DA Application – Accessibility Assessment

**Bennetts Green Retail Development
Pacific Highway,
Bennetts Green NSW 2290**

Prepared by:	Ray Franke
Prepared for:	Blueprint Australia
Job No.:	74664
Date:	8 th November 2017
Revision:	-

McKenzie Group Consulting Job No: 74664
DDA Comments - DA Date: 6'th Nov 2017

DRAWING TITLE
FAMILY RESTAURANT TENANCY
LOT 2

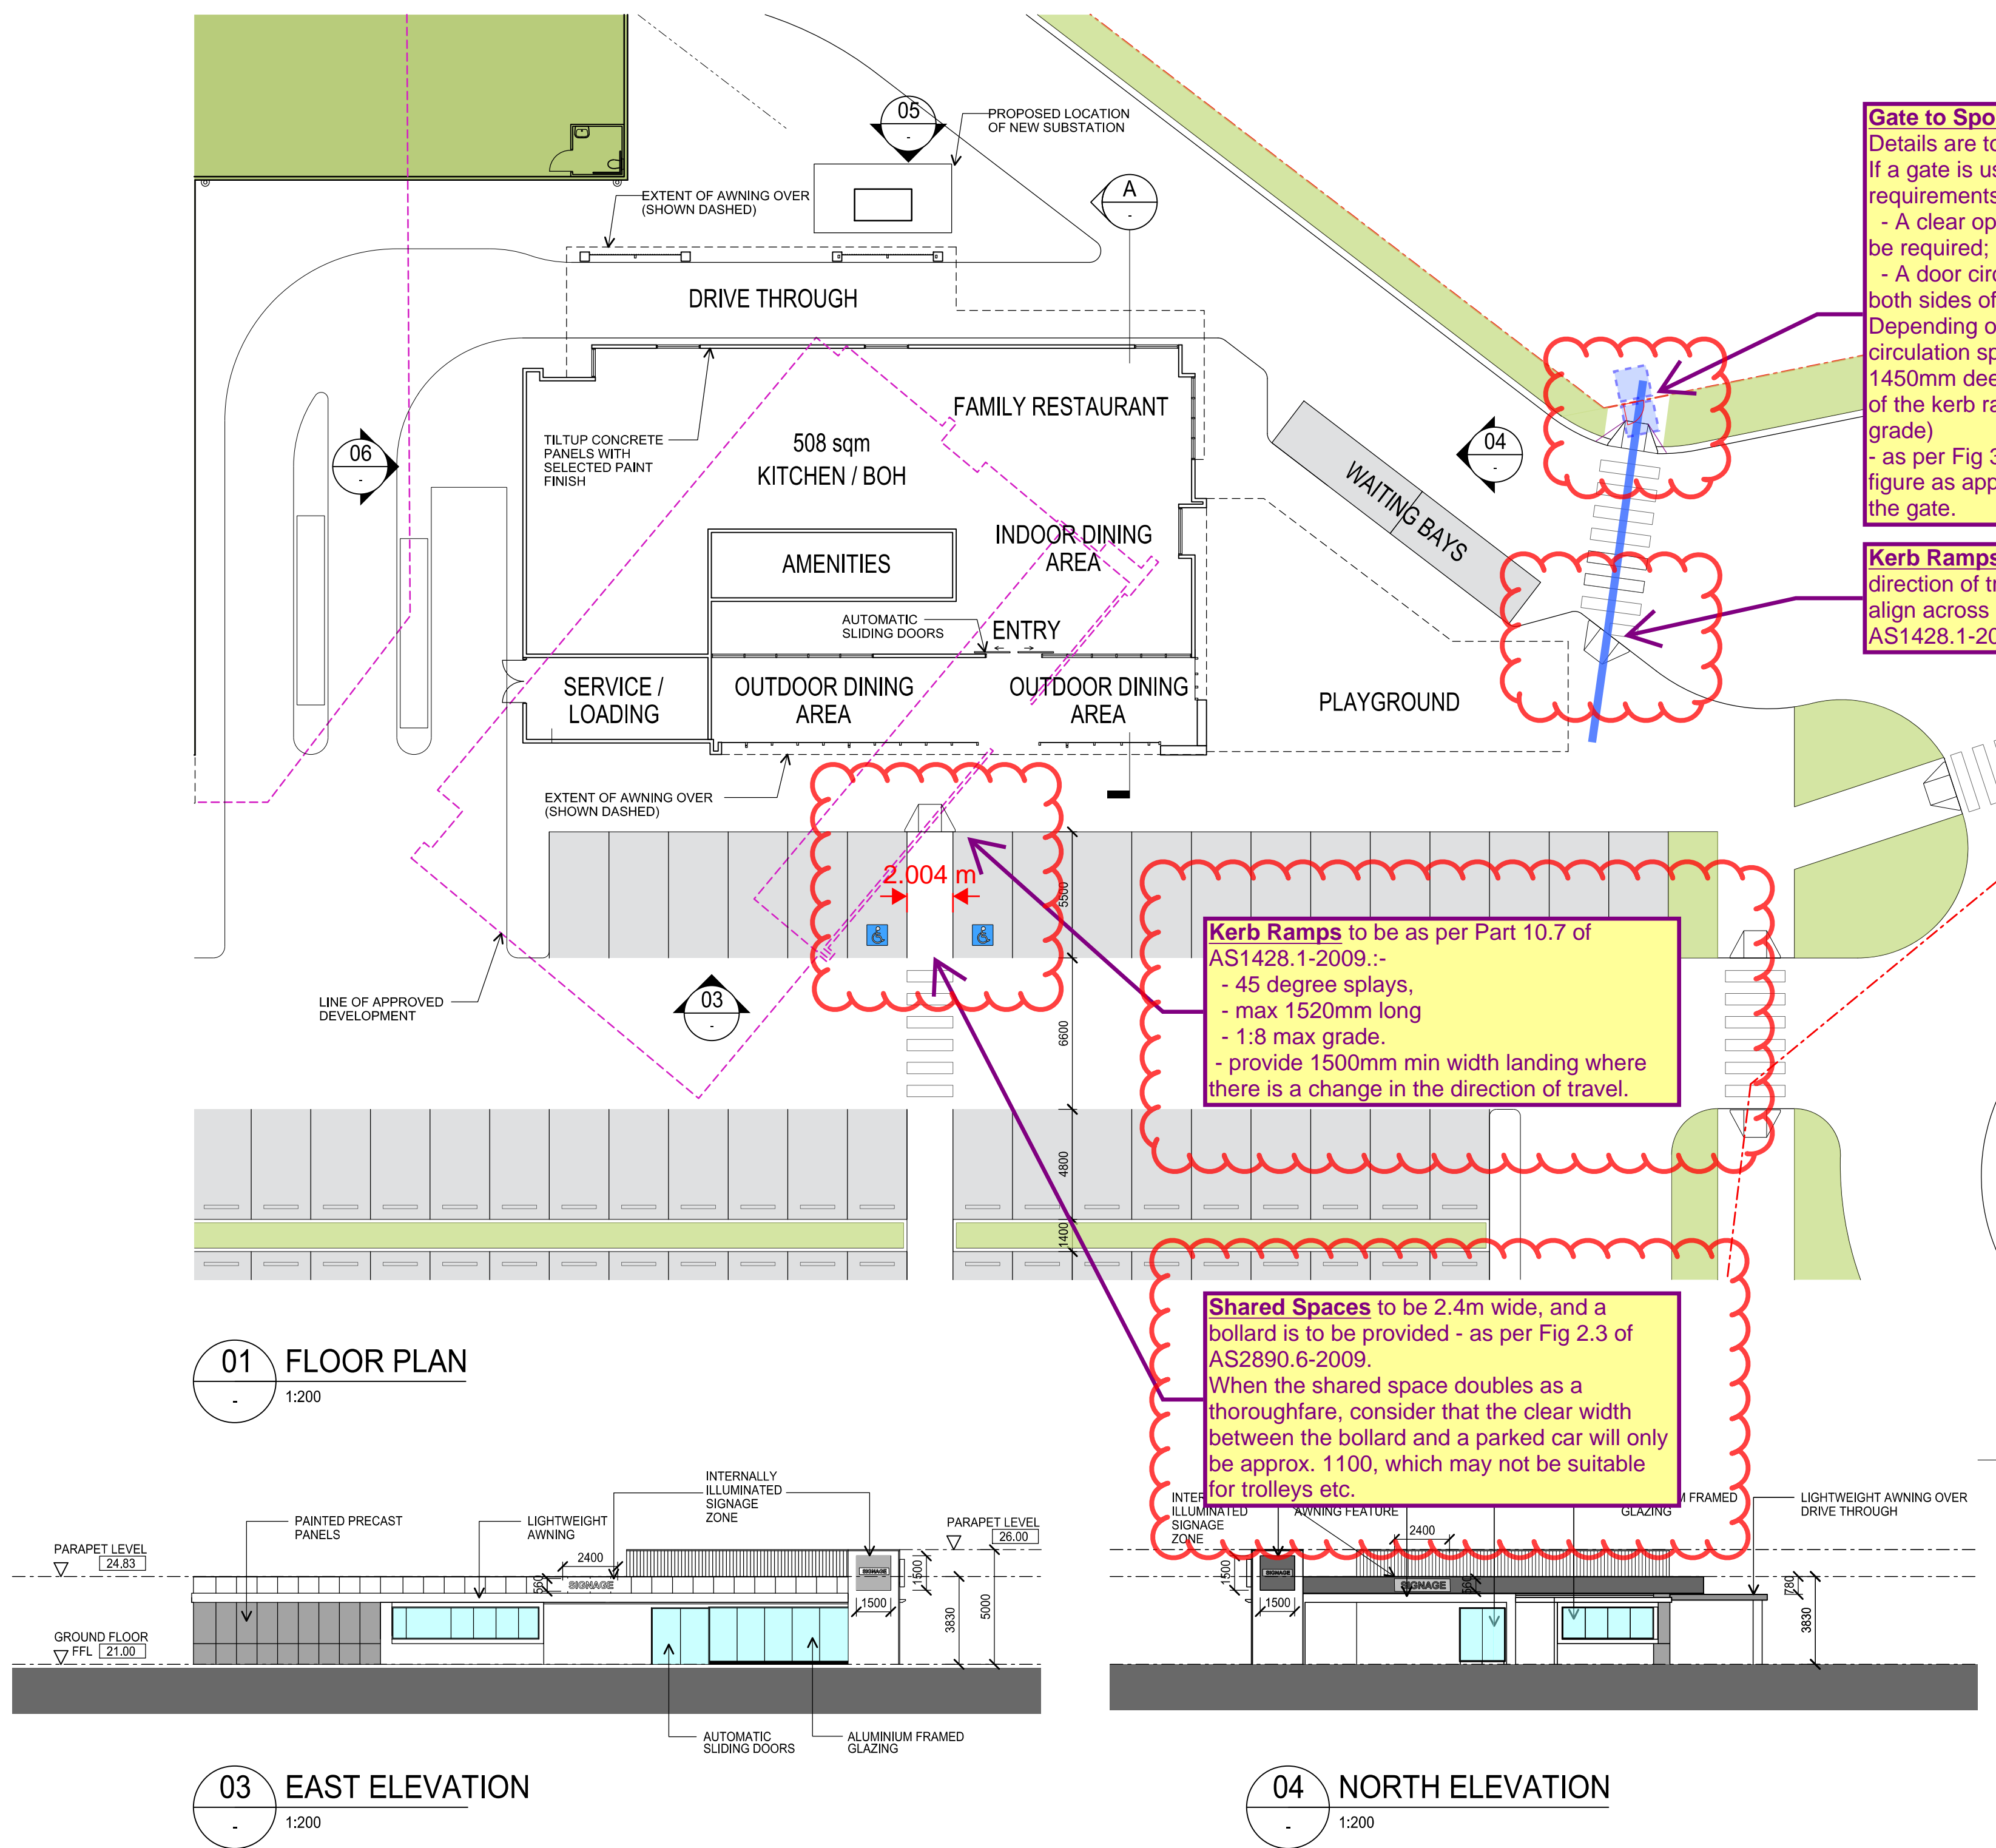
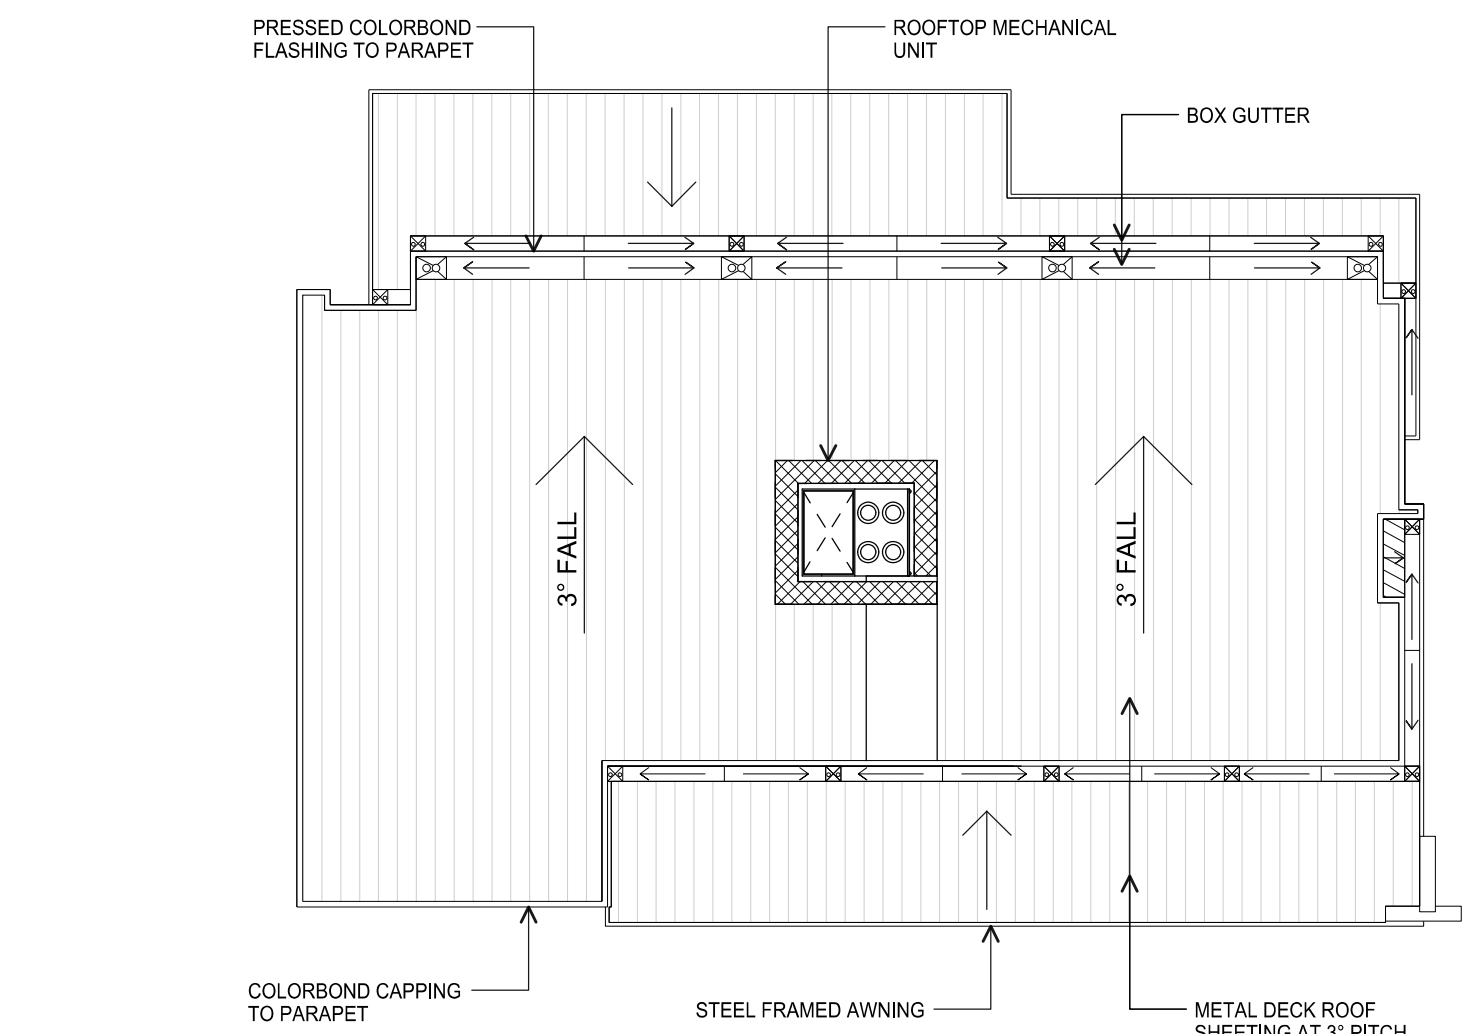
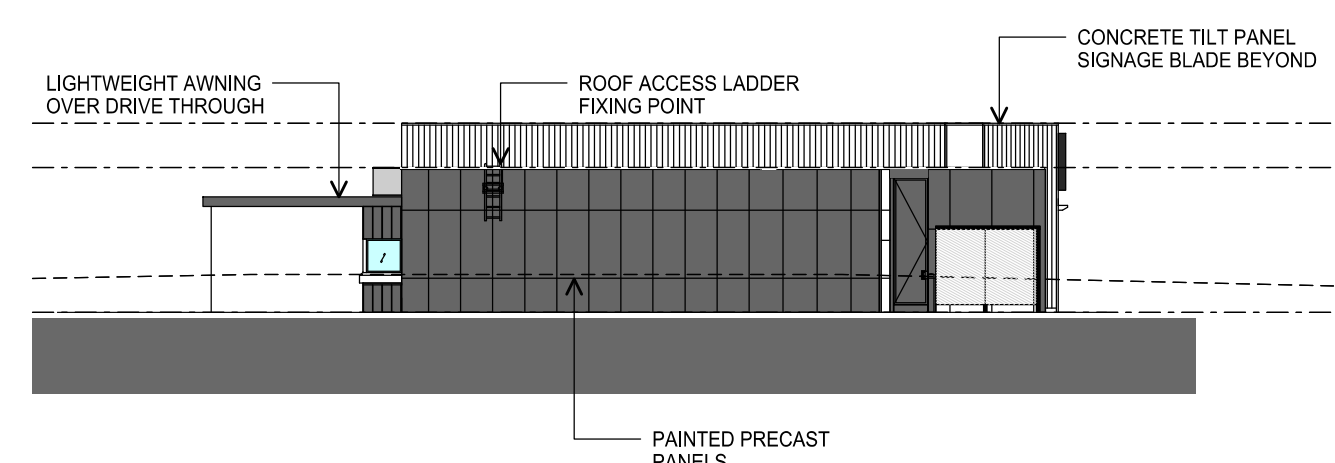
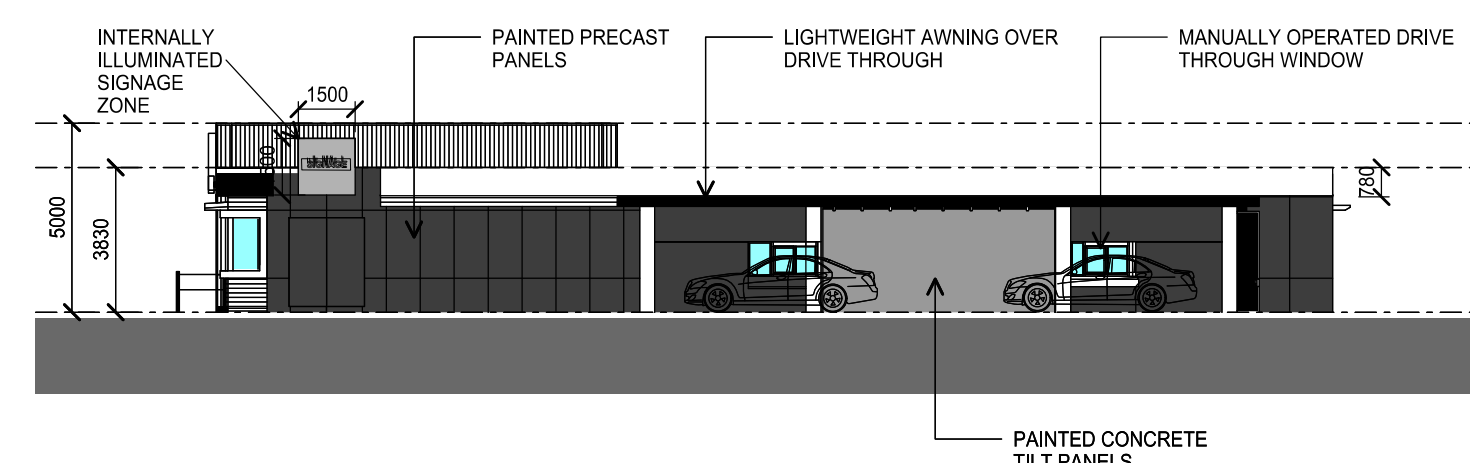
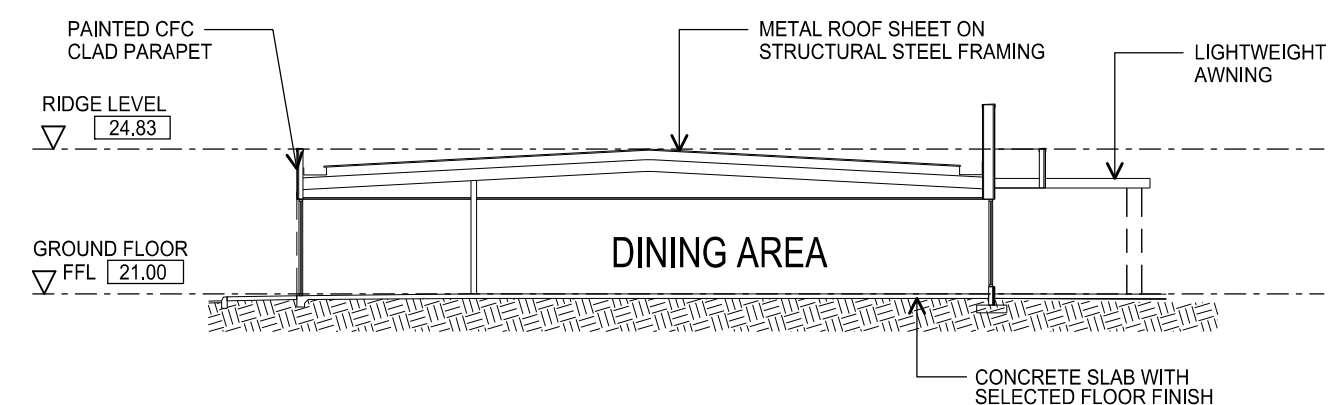
ACCESSIBLE ENTRIES & PATHS TO THEM
All Tenancy Entries are to be accessible. Confirm all levels, level changes and any ramping. All accessible entries are to have flush step free access - i.e. any ramping is to comply with AS1428.1-2009:- as either "walkways", "ramps", "step ramps", or "threshold ramps", as applicable.
